UNITED STATES PATENT AND TRADEMARK OFFICE

APPLICATION NO.	FILING DATE	FIRST NAMED INVENTOR	ATTORNEY DOCKET NO.	CONFIRMATION NO.
10/691,854	10/23/2003	Mark H. Falahee	FLH-10702/29	6727
25006	7590	03/23/2006	EXAMINER	
GIFFORD, KRASS, GROH, SPRINKLE & CITKOWSKI, P.C			PREBILIC, PAUL B	
PO BOX 7021			ART UNIT	
TROY, MI 48007-7021			PAPER NUMBER

Office Action Summary	Application No.		Applicant(s)	
	10/691,854		FALAHEE, MARK H.	
	Examiner		Art Unit	
	Paul B. Prebilic		3738

Fig - 7A

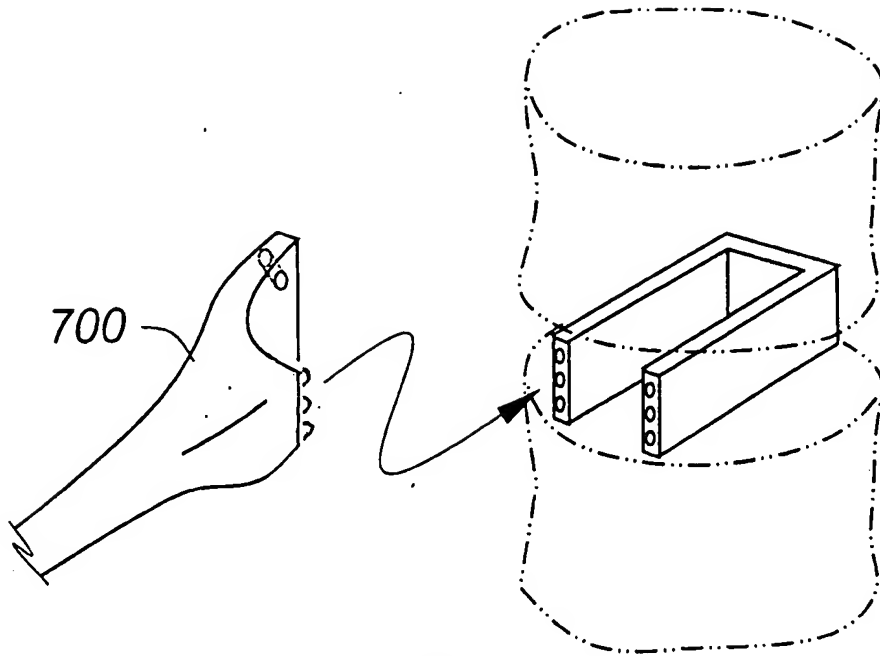
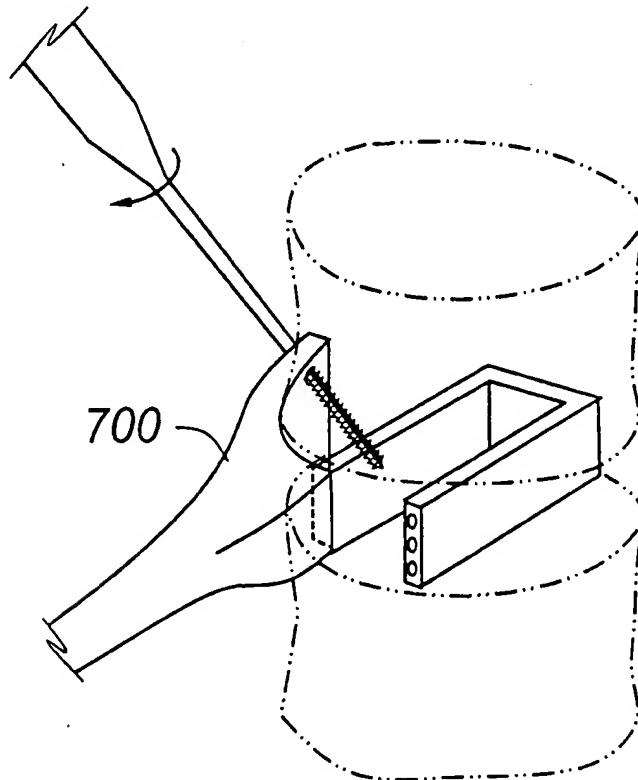
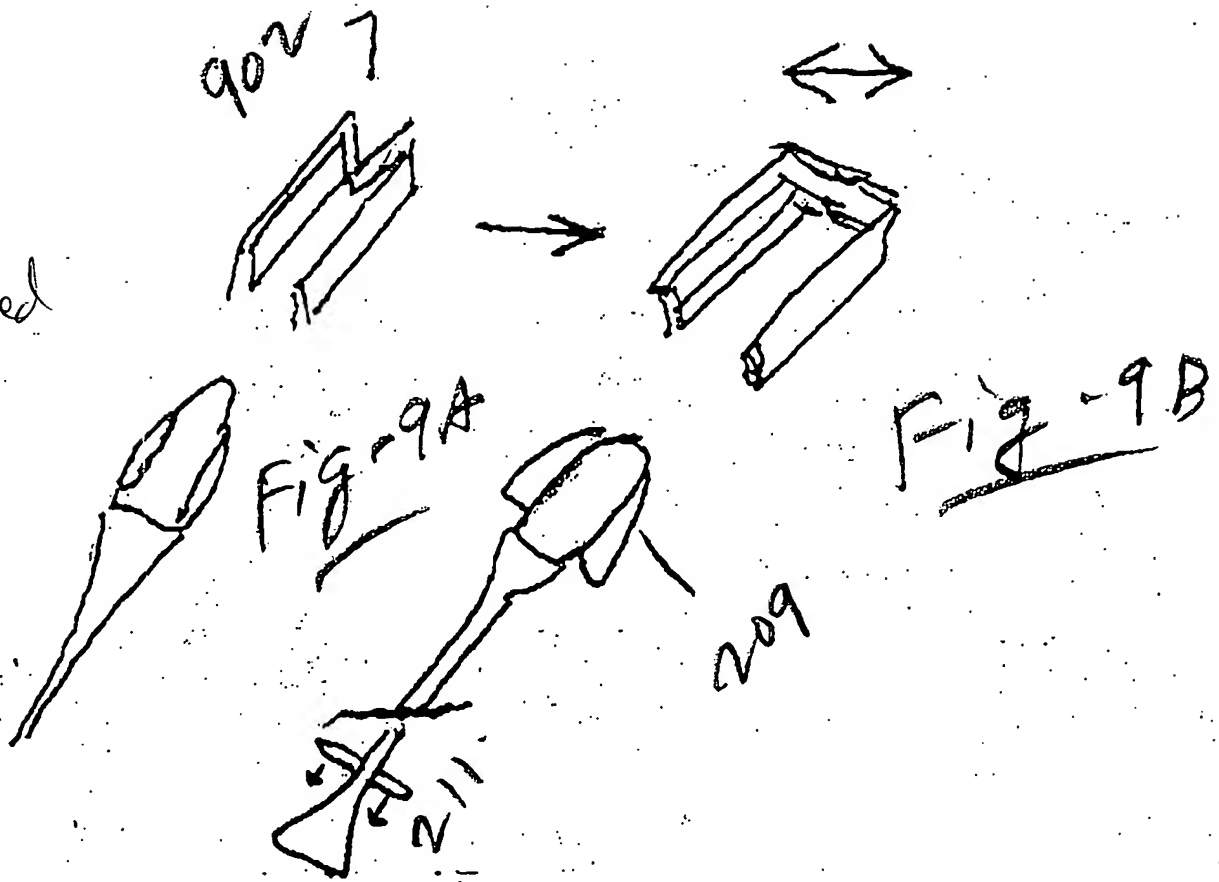
Proposed drawing changes were received on January 26, 2006. The proposed changes were not approved because Figures 7A and 7B attempt to add new matter to the specification. In particular, the detailed features of shape and details of the figures do not appear to have original support from the specification or original drawings. The drawing changes proposed for Figures 9A to 10B are not acceptable because they do not have projection lines indicating that they are expanded views. Furthermore, the drawings are of poor quality and do not comply with the requirements of Rule 84.

Changes
Not
Approved
FBP
3/20/06

New corrected drawings in compliance with 37 CFR 1.121(d) are required in this application because the ones filed June 13, 2005 are not acceptable. Applicant is advised to employ the services of a competent patent draftsman outside the Office, as the U.S. Patent and Trademark Office no longer prepares new drawings. The corrected drawings are required in reply to the Office action to avoid abandonment of the application. The requirement for corrected drawings will not be held in abeyance.

Fig - 10B

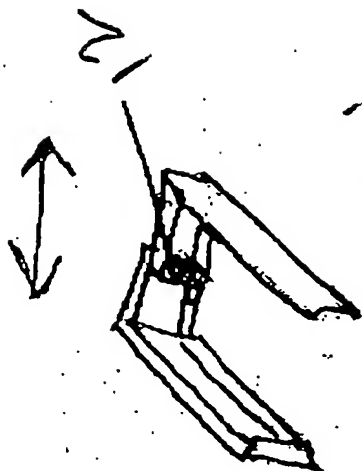
Changes
Not
Approved
3/20/06
